South Texas Project
Units 3 and 4
Docket Nos. 52-012 and 52-013
Revised Response to Request for Additional Information

RAI 09.01.02-9

Attachment: RAI 09.01.02-9 Response Revision 1

Summary: Provide additional information about the seismic loading for the nonlinear time history analysis of the spent fuel racks.

Figure 17: Baseline Corrected Displacement Seismic Time History

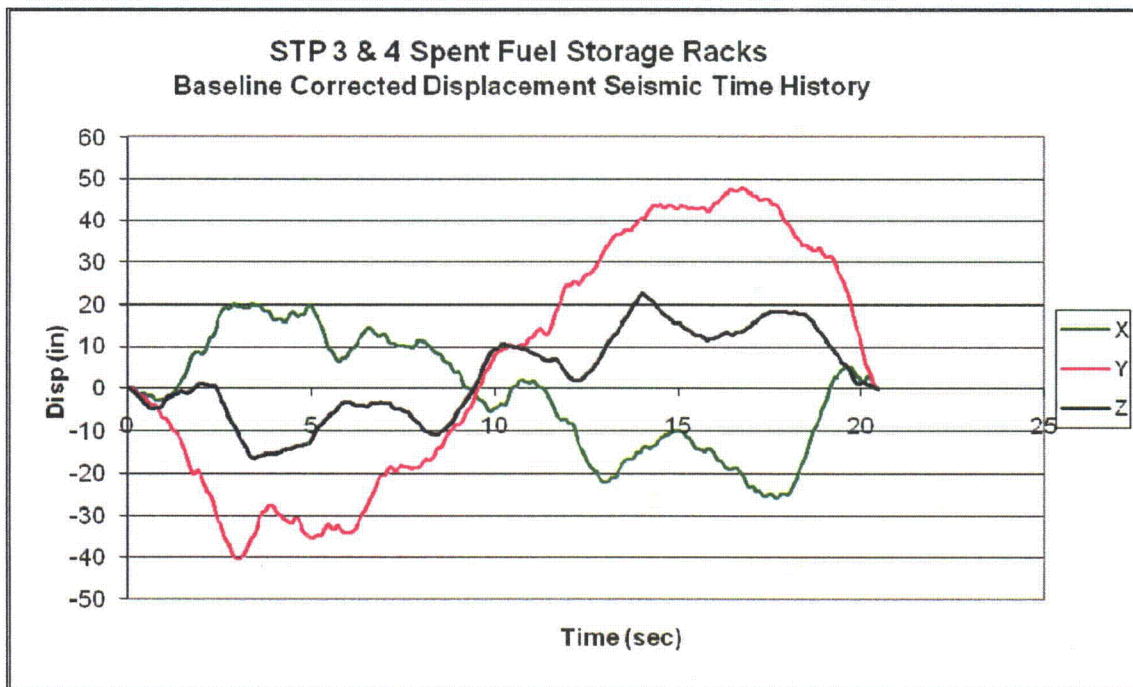
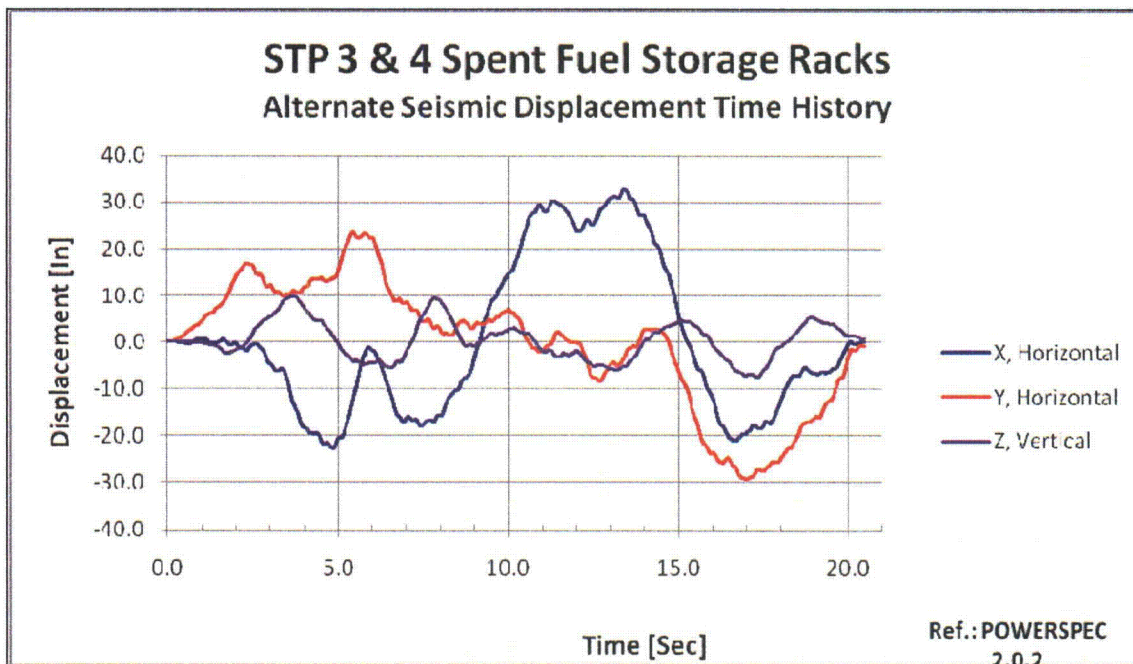
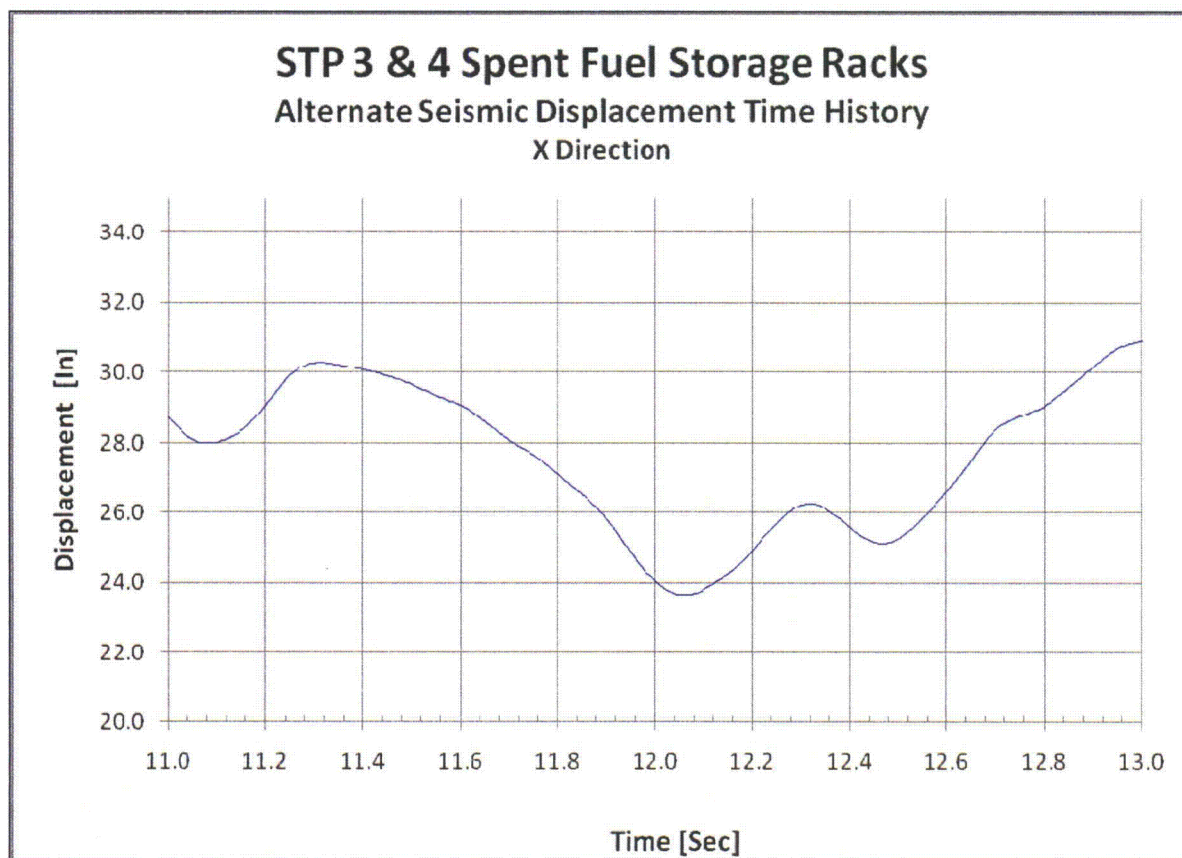
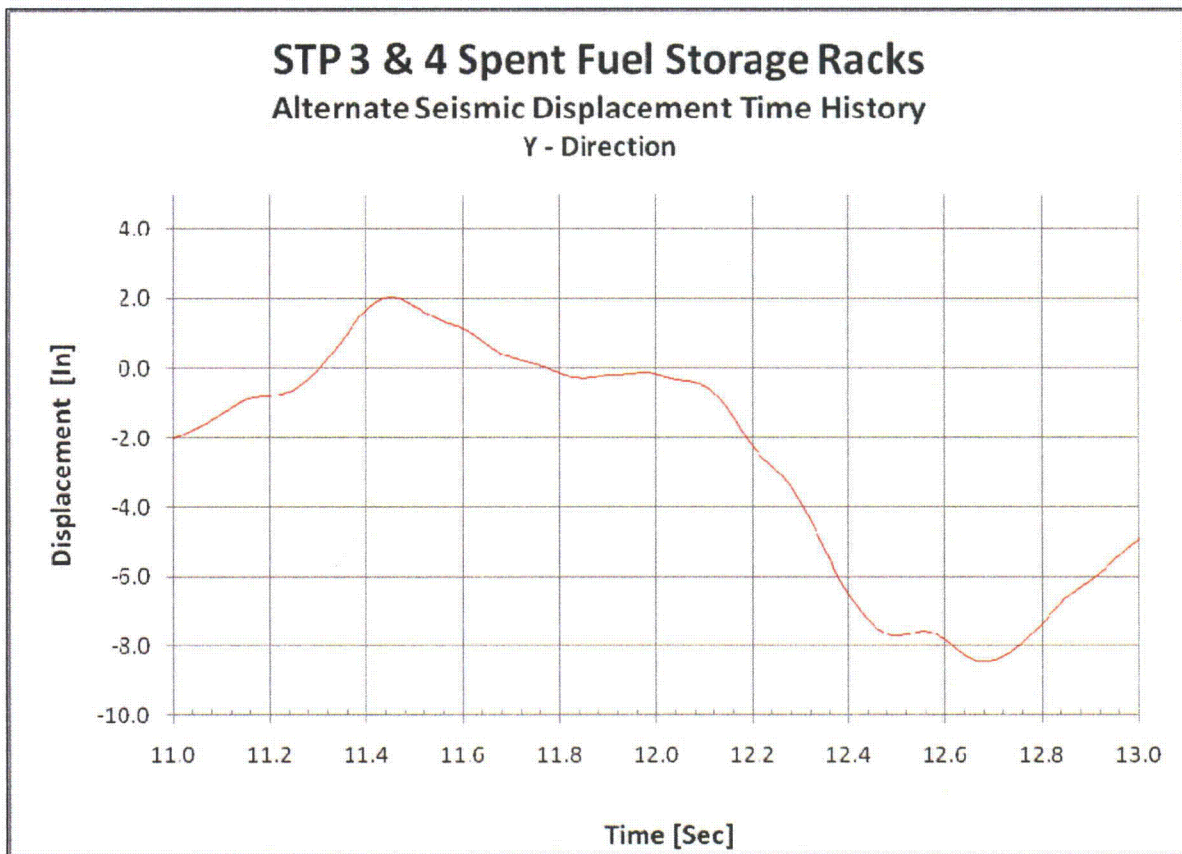
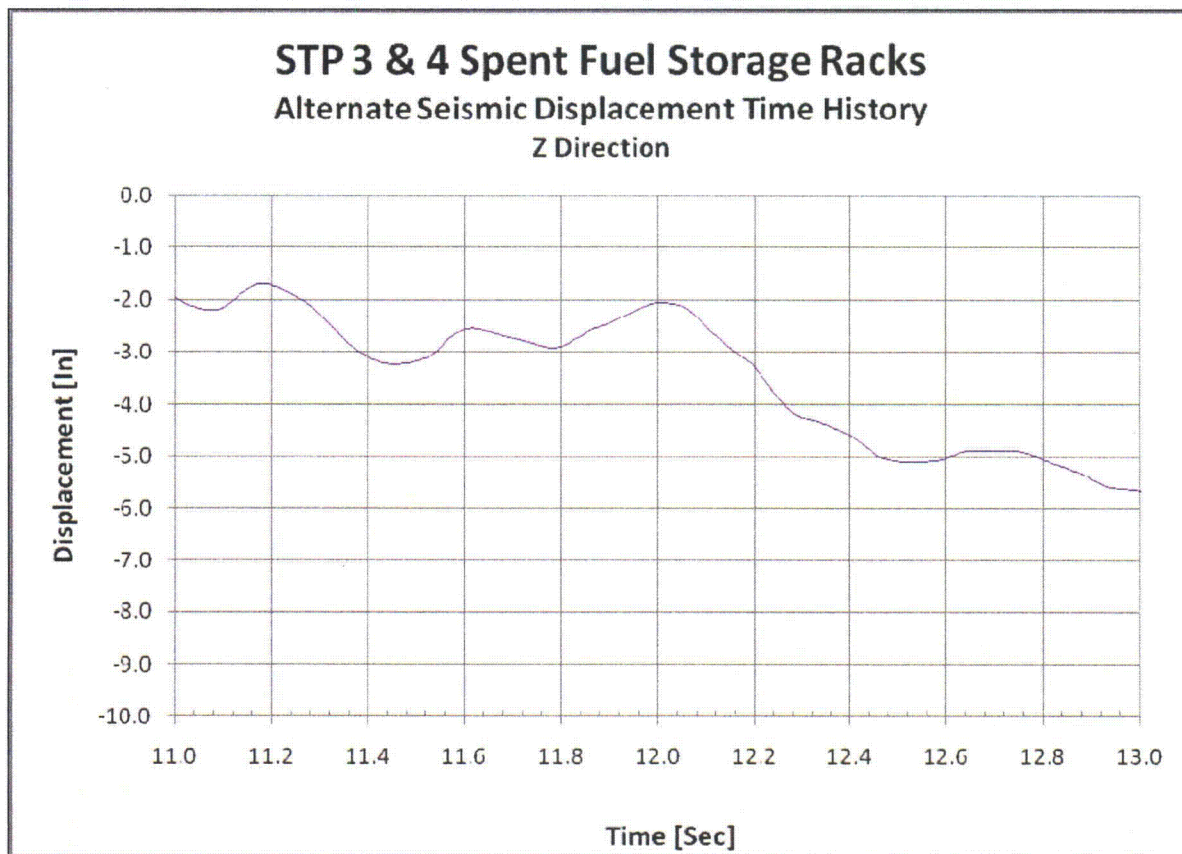
- f. The plots of the baseline corrected displacement time histories (x, y, z) presented in Figure 4-5 of the Technical Report exhibit several characteristics that require clarification and explanation: (1) All 3 displacement time histories exhibit a dominant sinusoidal response with a period which is same as the duration of the acceleration time history (2) All 3 displacements are zero at three specific time steps. (3) Although there is only 1 horizontal target spectrum, the peak x displacement is approximately $\frac{1}{2}$ of the peak y displacement. (4) The 2 horizontal displacement histories are completely out-of-phase with each other; the vertical displacement history is perfectly in-phase with y and completely out-of-phase with x. Describe how the displacement time histories are developed from the synthetic acceleration time histories, and provide the technical basis for the adequacy of the generated displacement time histories.

The comparison between the baseline corrected and alternate displacement time histories (double integration of the synthesized acceleration time histories using the second method described in the response to RAI 09.01.02-9(d)) is shown in Figures 17 and 18, respectively. Figures 17 and 18 both show low frequency, large amplitude displacements containing superimposed high frequency, low amplitude displacements. The fuel racks dynamically respond to the higher frequency smaller amplitude cyclic waves shown in both figures. Figures 19, 20, and 21 show the alternate displacement time history on a magnified time scale for each of the applied directions. Figures 19, 20, and 21 reflect high frequency, low amplitude characteristics that are similar to Figures 13, 14, and 15.

The baseline corrected time histories shown in Technical Report Figure 4-5 are developed from three statistically independent synthesized acceleration time histories satisfying all the criteria of SRP 3.7.1. Validation that these time histories are adequate for the fuel rack seismic analysis is demonstrated by comparison with displacement time histories derived from synthesized acceleration time histories using an independent method. Both sets of displacement time histories

yielded similar seismic response results when applied to the fuel rack. Therefore, both time histories are equally valid for the fuel rack seismic analysis and it is not necessary to replace the existing time history input.
